ADEQUACY OF STATION ELECTRIC DISTRIBUTION SYSTEM VOLTAGES,
INDIAN POINT NUCLEAR POWER STATION--UNIT NO. 3,
DOCKET NO. 50-286

Technical Evaluation Report

ADEQUACY OF STATION ELECTRIC DISTRIBUTION SYSTEM VOLTAGES
INDIAN POINT NUCLEAR POWER STATION--UNIT NO. 3

Docket No. 50-286

Figure 1. Indian Point Unit 3 electrical single-line diagram.

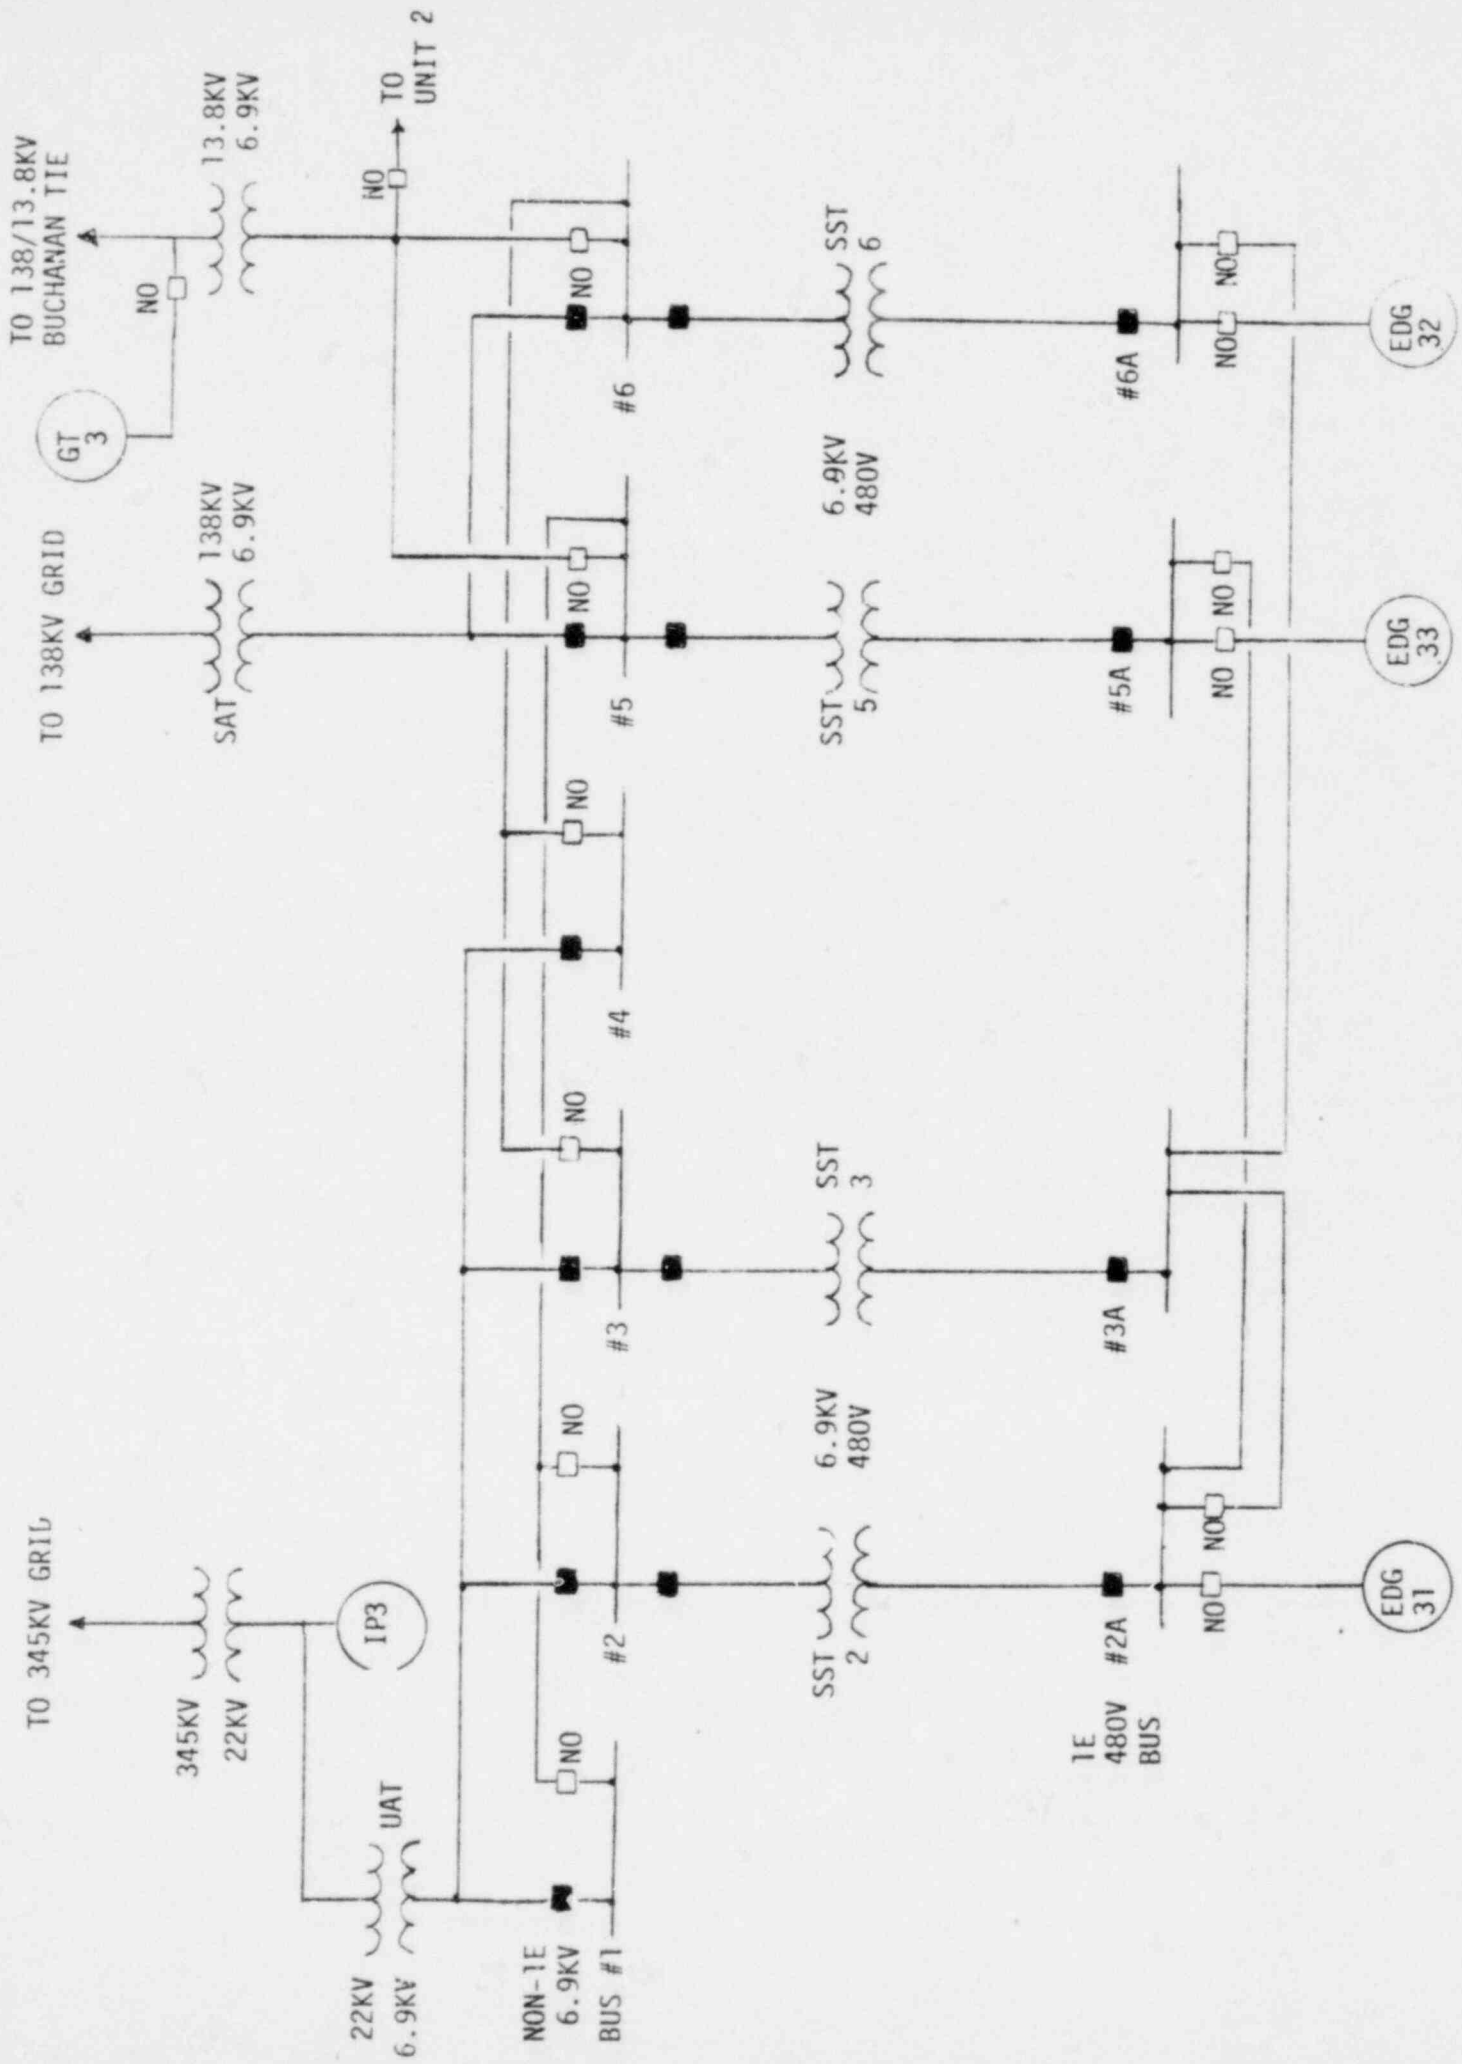
Indian Point is the site of two operating nuclear units. The preferred (138kV) and alternate (13.8kV) offsite sources are independently connected to the onsite distribution system of each unit. However, the alternate offsite source of each unit can simultaneously supply 1E loads of the other unit through a tie breaker. PASNY has not provided an analysis for this connection. Additionally, the Indian Point Station has three gas turbine generators that could supply power to class 1E loads individually or in combination to one unit or both units through the tie breaker. No voltage analysis for this supply has been provided to the NRC.

- 1: Voltages within the operating limits of the class 1E equipment have not been supplied for all projected combinations of plant load and normal offsite power grid conditions, considering an accident in one unit and the safe shutdown of the other unit.

- a: PASNY should either provide an analysis to show that one 13.8kV gas turbine generator can supply satisfactory voltage to all possible connected 1E loads (on both Units 2 and 3) or have LCO requirements in the Technical Specifications preventing their use.

- b: PASNY should either provide an analysis to show that the Buchanan 138/13.8kV tie, through the 13.8/6.9kV transformer can supply all class 1E equipment to both units through the Unit 3/Unit 2 tie breaker considering the Buchanan grid at its minimum expected voltage or provide LCO requirements in the Technical Specifications preventing the use of this tie breaker to 1E loads during operation of both Unit 3 and Unit 2.

- 2: PASNY should provide LCOs in their Technical Specifications which would require that the circuit breaker control switches located in the control room, which control the automatic transfer of the 6.9kV buses 1, 2, 3, and 4 to buses 5 and 6, be "locked out" and tagged anytime the 13.8 kV source is connected to buses 5 and 6. This situation is presently covered under Standard Operating Procedure No: SOP-EL-5.
